PLANNING BOARD AGENDA
MAY 12, 2022 – 7:00 P.M.

RE: Site Plan for Demag & Ademi
552 Route 6
TM#: 75.12-2-1 & 2

Please find enclosed the following plans and documents in support of an application for site plan approval for the above referenced project:

In response to comments received from Town Engineer Richard Franzetti, PE, dated April 4, 2022, we offer the following responses:

VEHICLE MANUEVER PLAN-PROPANE TANKER 1" = 50"

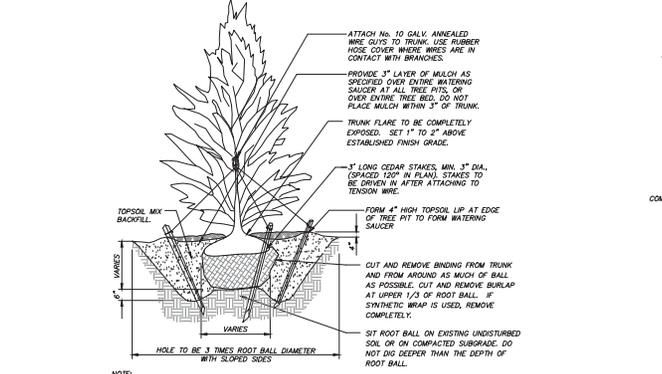
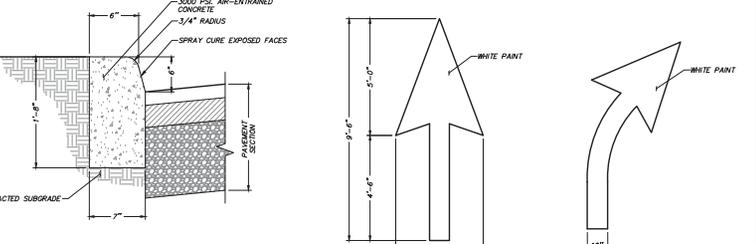
- Typically, one to three delivery trucks could be on site, but currently no more than four are anticipated. Additionally, a more or less weekly bulk delivery from a tanker would be anticipated. See the vehicle maneuvers on drawing D-1. Typically, there will one employee on site in the office, and up to three delivery drivers depending on the daily schedule.

- Traffic and vehicle movements are shown on drawing D-1.
 - Site distance calculations are shown on drawing SP-1.
 - A driveway profile will be provided with a future submission as the entrance plan for the NYSDOT is advanced.
